30% Preliminary Design
Value Engineering Report

TOWN OF MASHPEE, MASSACHUSETTS
MASHPEE SEWER COMMISSION
PRELIMINARY DESIGN OF MASHPEE WATER
RESOURCE RECOVERY FACILITY (WRRF)
30% REVIEW SUBMITTAL

NOVEMBER 2019
11188223

PROCESS BUILDING PARTIAL PLAN - PUMP ROOM

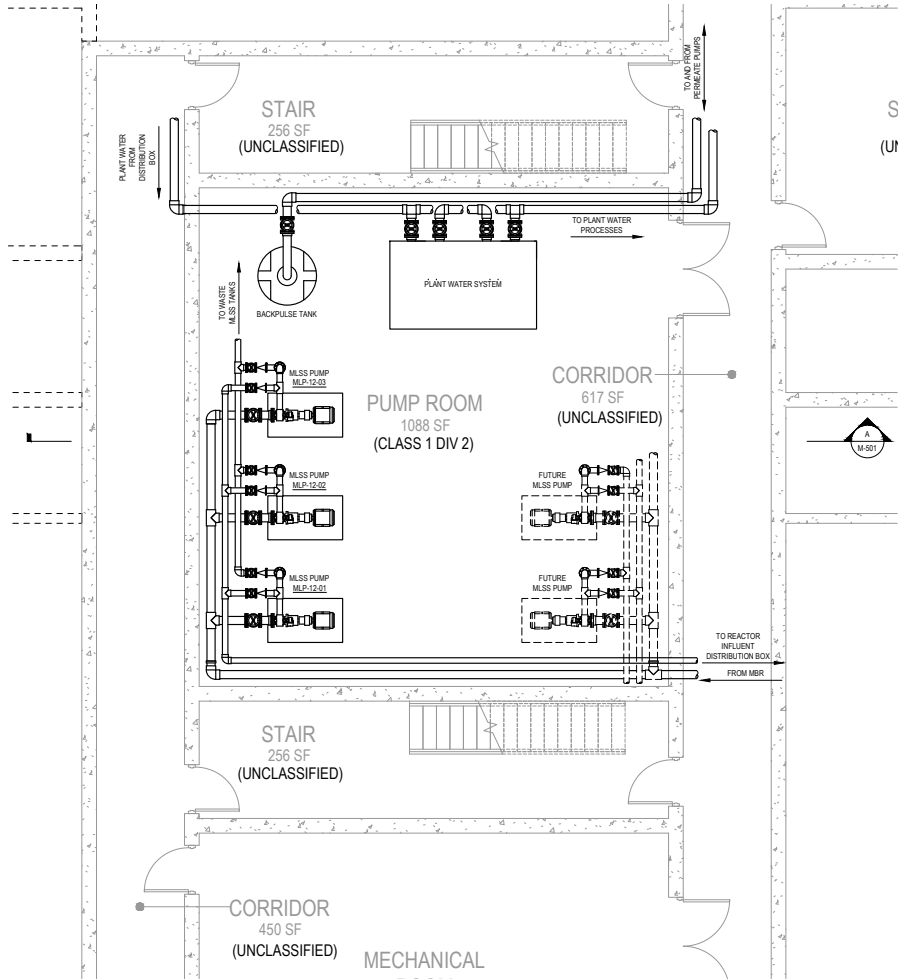
18. Drawing M-500 – It is suggested to have water flushed mechanical seals. Use town water with BFP.
19. Drawing M-500 – Are MLSS flow meters to be provided?

20. Drawing M-500 – For UV bulb dip cleaning, Dry anhydrous citric acid will be needed.
21. Drawing M-600 – Electric crane is recommended for UV module removal.

Client	TOWN OF MASHPEE, MA
Project	PRELIMINARY DESIGN OF MASHPEE WRRF
Title	PROCESS BUILDING PARTIAL PLAN - UV DISINFECTION ROOM
Original No.	1118223
Arch D	M-600
Sheet No.	M-600
Sheet	of

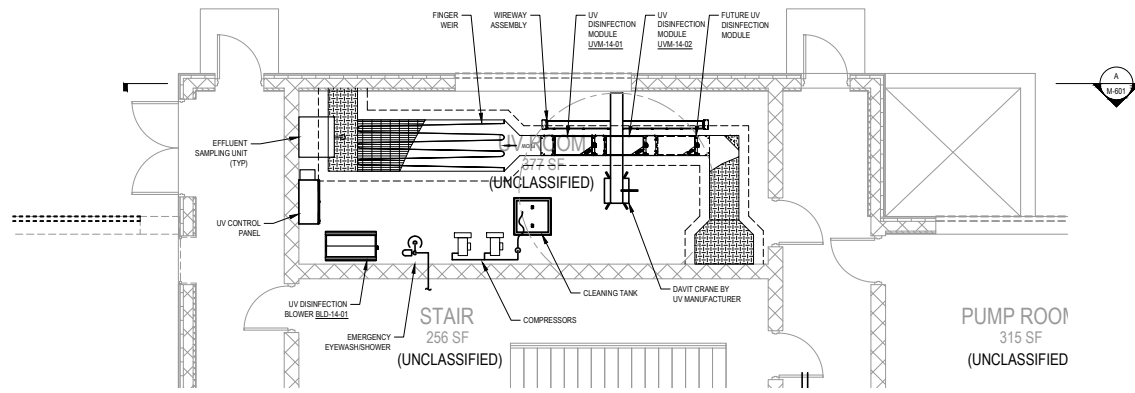
22. Drawing M-600 – UV trough weir with gate valve to flush UV channel may want to be explored, as we have experienced problems with finger weirs.
23. Drawing M-600 – Explore the idea of potentially have the UV module cleaning tank drain back to the headworks.

**PROCESS BUILDING PARTIAL PLAN -
CHEMICAL ROOM**

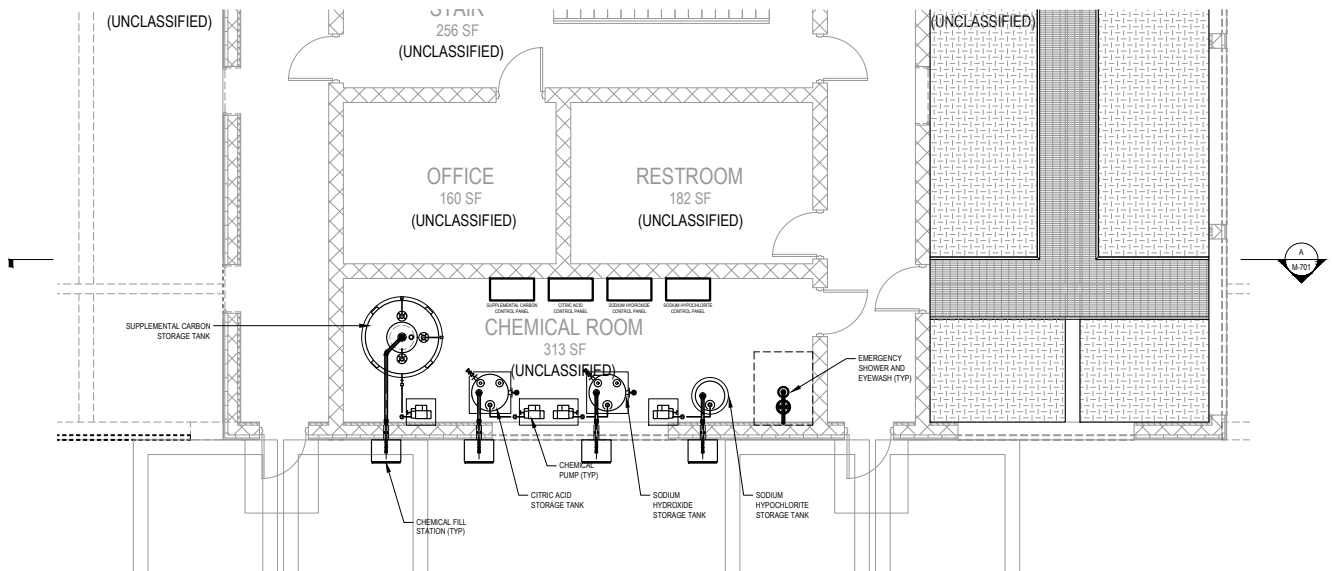
24. Drawing M-700 – Specify proper PVC pipe/cleaner and adhesives matched to the chemical being used. Sodium Hypochlorite leaks are common due to improper glue/cleaner/primer being used.

25. Drawing M-700 – Spare chemical feed pumps are suggested. Plan currently show one each.
26. Drawing M-701 – Will chemical storage tanks have level indicators such as ultrasonic units? M-701 – MBK

**PROCESS BUILDING SECTION -
CHEMICAL ROOM**

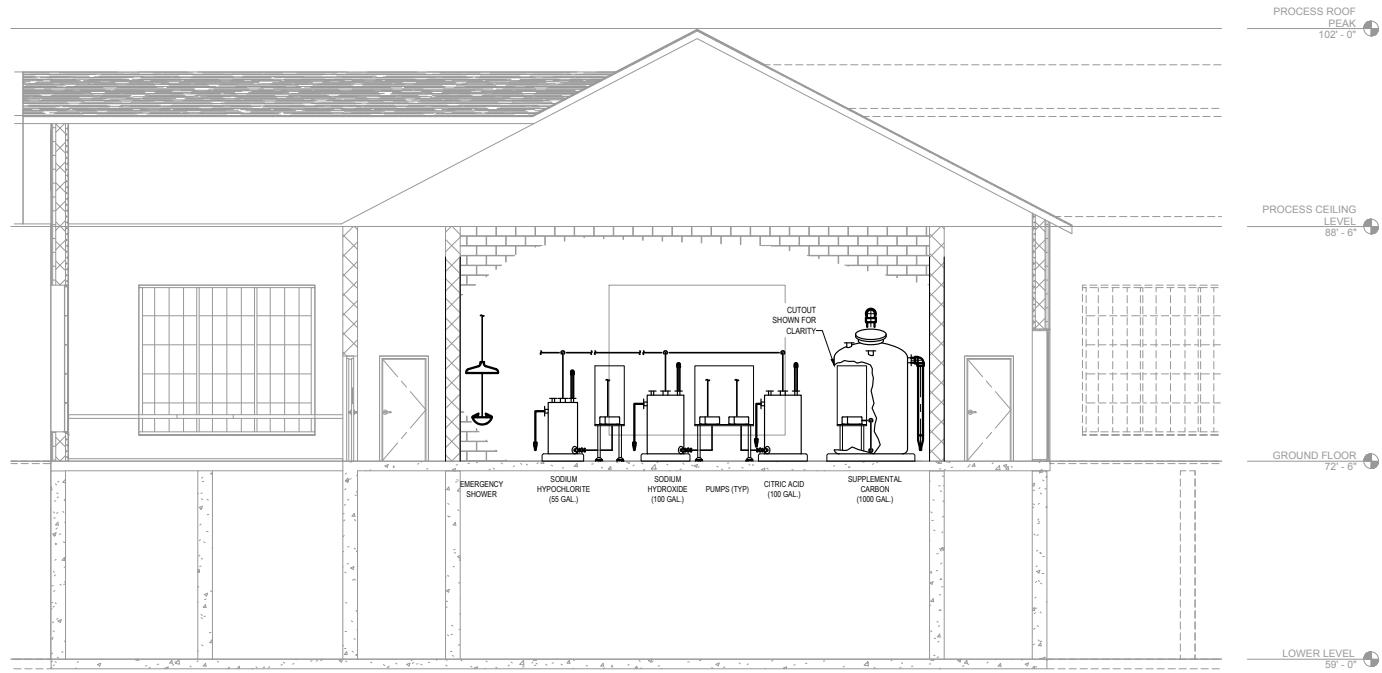
27. Drawing M-701 – It is suggested to install floor drains in the chemical room for emergency shower drain and clean-up.
28. Drawing M-800 – MLSS tank diffuser header pipe supports are suggested to be stainless steel.

Client	TOWN OF MASHPEE, MA
Project	PRELIMINARY DESIGN OF MASHPEE WRRF DISTRIBUTION STRUCTURES - PLANS
Title	
Project No.	1118223
Original Date	
Arch D	Sheet No. M-850
Sheet	of

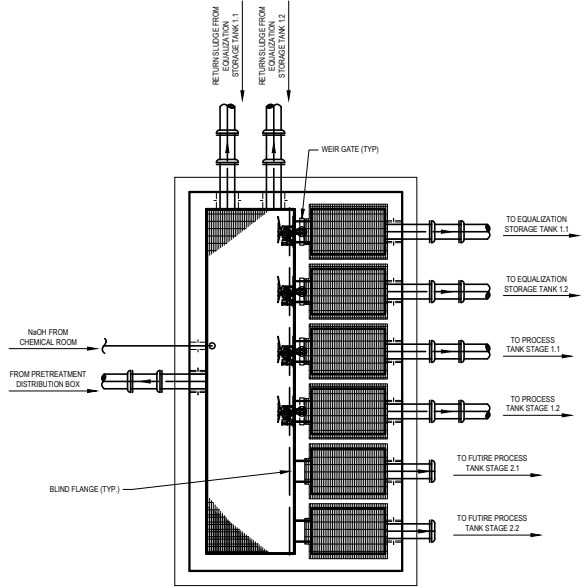
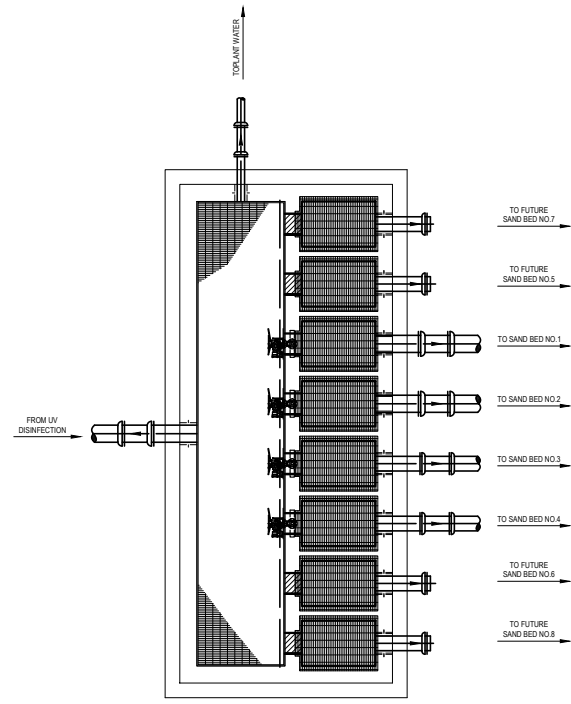
Drawing M-850 shows that the current plan for covering the distribution structures is grating.			
ALTERNATIVE CONCEPT:			
The primary and secondary distribution structures appear to show grating. Consider solid covers to improve odor containment. Consider precast concrete for the smaller primary structure.			
ADVANTAGES:		DISADVANTAGES:	
<ul style="list-style-type: none"> • Solid covers will improve odor containment. • Precast structures will reduce cost and construction disturbance. 			
COST SUMMARY	Initial Cost	O&M LCC	Net Present Value
Original Concept	\$	\$	\$
Alternative Concept	\$	\$	\$
Additional Savings	\$	\$	\$
Team Member: Kent M. Nichols, Jr., P.E.		Discipline: Wastewater Process

Client	TOWN OF MASHPEE, MA
Project	PRELIMINARY DESIGN OF MASHPEE WRRF
Title	PROCESS BUILDING PLANS
Original No.	11188223
Arch D	Sheet No. A-200
Sheet	of 30

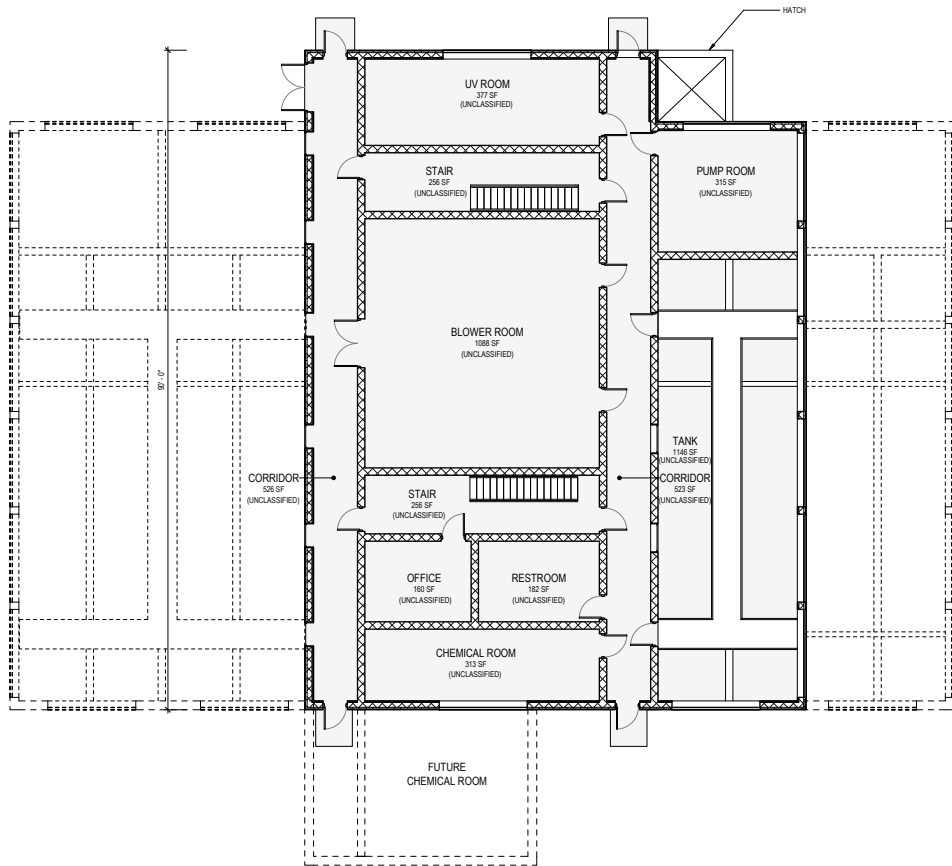
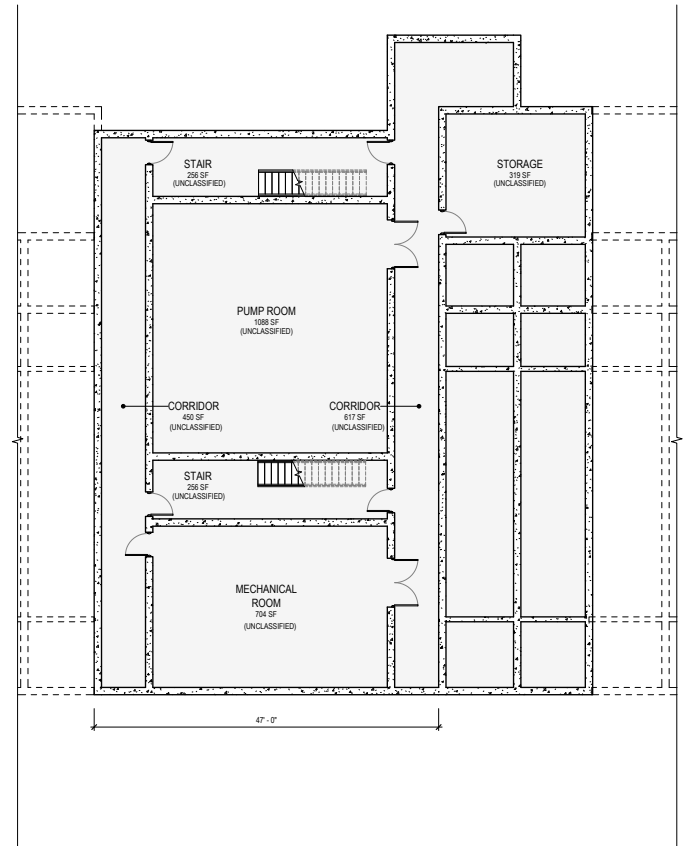
VE CONCEPT			
Project: Mashpee WWTF Preliminary Design		Idea No. B-2	Page No.
Process Area/Category: Process Building			
TITLE: Control Room		Weighted Total:	
		Ranking:	
ORIGINAL CONCEPT: PROCESS AREA/CATEGORY			
In drawings M-200 and A-200, a room labeled “Office” is shown in the Process Building.			
ALTERNATIVE CONCEPT:			
Consider changing the “Office” shown in the Process Building to be a “Control Room”. The plan does not otherwise provide a place for the head end SCADA to be viewed and operations manuals, records, etc. to be available for operator troubleshooting. A desk in this space and file storage may be supplemental uses for the space as well.			
ADVANTAGES:		DISADVANTAGES:	
<ul style="list-style-type: none"> Combine “Office” Space and SCADA system space into one room. 			
COST SUMMARY		Initial Cost	O&M LCC
Original Concept	\$	\$	\$
Alternative Concept	\$	\$	\$
Additional Savings	\$	\$	\$
Team Member: Kent M Nichols, Jr., P.E.		Discipline: Wastewater Process

VE CONCEPT			
Project: Mashpee WWTF Preliminary Design		Idea No. B-3	Page No.
Process Area/Category: Process Building			
TITLE: Restrooms		Weighted Total:	
		Ranking:	
ORIGINAL CONCEPT: PROCESS AREA/CATEGORY			
The drawings M-200 & A-200 show a single restroom with one access in the Process Building.			
ALTERNATIVE CONCEPT:			
We recommend consulting formally with the local Building Department as to requirements for separate men's and women's toilet facilities, and related code requirements. If two restrooms are needed in the initial building, then the plans should be adjusted for the required space. Provisions are needed for a shower area, and in a smaller facility this may be best set up as a separately accessed room.			
ADVANTAGES:		DISADVANTAGES:	
COST SUMMARY		Initial Cost	O&M LCC
Original Concept	\$	\$	\$
Alternative Concept	\$	\$	\$
Additional Savings	\$	\$	\$
Team Member: Kent M. Nichols, Jr. P.E.		Discipline: Wastewater Process

Client	TOWN OF MASHPEE, MA		
Project	PRELIMINARY DESIGN OF MASHPEE WRRF		
Title	ELECTRICAL DIAGRAM		
Project No.	11188223		
Arch D	Sheet No.		E-001
Sheet	of

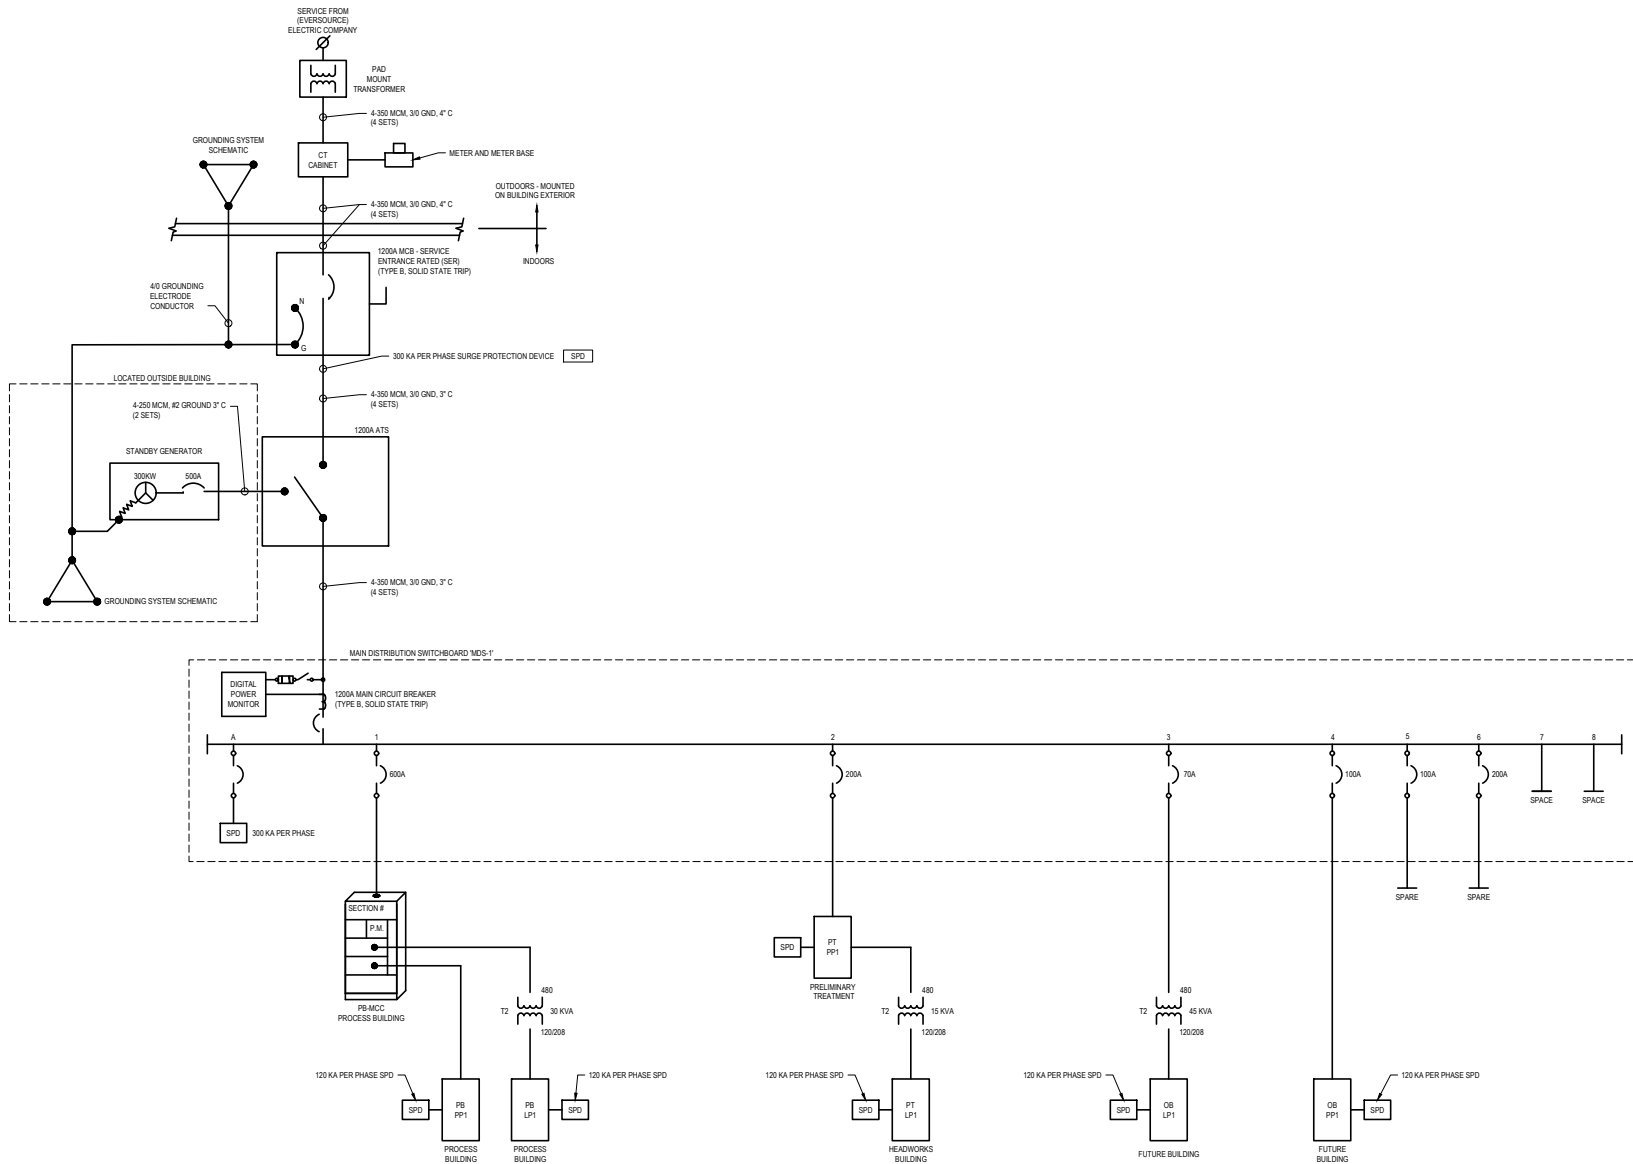
33. Drawing E-001 – A permanently installed natural gas or diesel emergency generator load bank is indicated. An option would be a receptacle on the generator main disconnect for ease of hooking up a portable load bank periodically (i.e. annually during generator PM work).

34. Drawing E-001 – Consider dual electric grid feeds.
35. Drawing E-001 – Consider bypass contactors for VFD's.
36. Drawing I-001 – Consider SCADA text capabilities as a back-up to the primary voice calls for alarms.
